## PUBLIC HEARING MEMORANDUM

SUBJECT: **Petition #217-21** for SPECIAL PERMIT/SITE PLAN APPROVAL to alter a nonconforming retail use to allow a retail drive-in business, to allow parking in the side and front setbacks and within five feet of the street, to allow a reduced required aisle width, to waive perimeter screening requirements and to waive outdoor lighting requirements at **1021 Boylston Street**, Ward 5, Newton Highlands, on land known as Section 51 Block 26 Lot 03, containing approximately 17,280 sq. ft. of land in a district zoned MULTI RESIDENCE 2. Ref: Sec. 7.3.3, 7.4, 7.8.2.C.2, 6.4.11 of the City of Newton Rev Zoning Ord, 2017.

**1021 Boylston Street**

**ZONING REVIEW MEMORANDUM**

**Proposed Site Plan (with landscaping)**

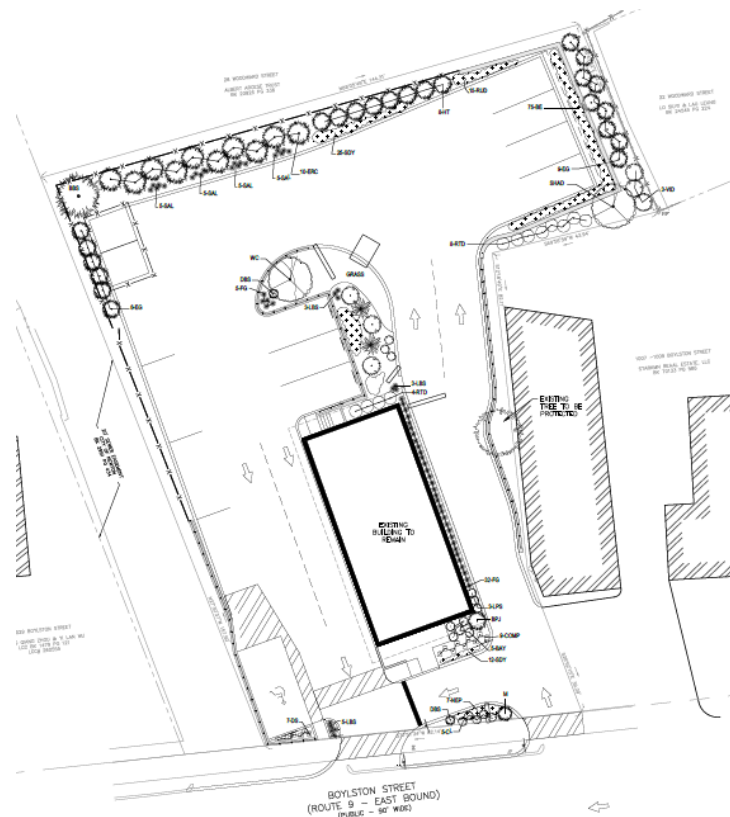
That said, the proposed design does require relief from certain parking facility dimension requirements. As parking stalls may not be located in any required front and side setbacks and/or within five feet of the street (Sec. 5.1.8.A.1), an exception to this regulation would be required to allow the nine parking stalls within side setbacks- four in the right (east) setback and five in the left (west) setback. Of the latter, the front most space (an accessible stall), would also be located within the front setback and five feet of the street, a condition that also requires a special permit.

Section 5.1.8.C.1 requires a minimum 24-foot width for maneuvering aisles serving 90-degree parking stalls. Three such stalls located immediately to the rear of the building would be served by a 13-foot wide aisle width, requiring a special permit.

Perimeter screening meeting the required dimensions for outdoor parking facilities containing more than five stalls per Sec. 5.1.9.A is proposed at the rear (north) and northeastern property lines. That said, there does appear to be a gap at the right end of the rear property line. The petitioner should be prepared to discuss this as well as the height of the walls shown on the site plans at this and other locations on the property.

The western lot line and the front sections of the property lack the required screening, requiring a waiver per Sec. 5.1.13.

The submitted lighting plan indicates that portions of the parking area would not meet the requirement per Sec. 5.1.10.A that outdoor parking facilities used at night provide lighting with a minimum intensity of one-foot candle on the entire surface. As such, the proposal requires an exception per Sec. 5.1.13 (please note that it does not appear that the proposed lighting would “spill” onto neighboring properties).

The Planning Department notes that issues related to screening and lighting, as well as the function and volume of the ordering system speakers, are of concern considering that the subject property is located within a residential zoning district and directly abuts three residential properties with several more located in close proximity. The petitioner should be prepared to address how negative impacts on nearby homes would be appropriately mitigated.
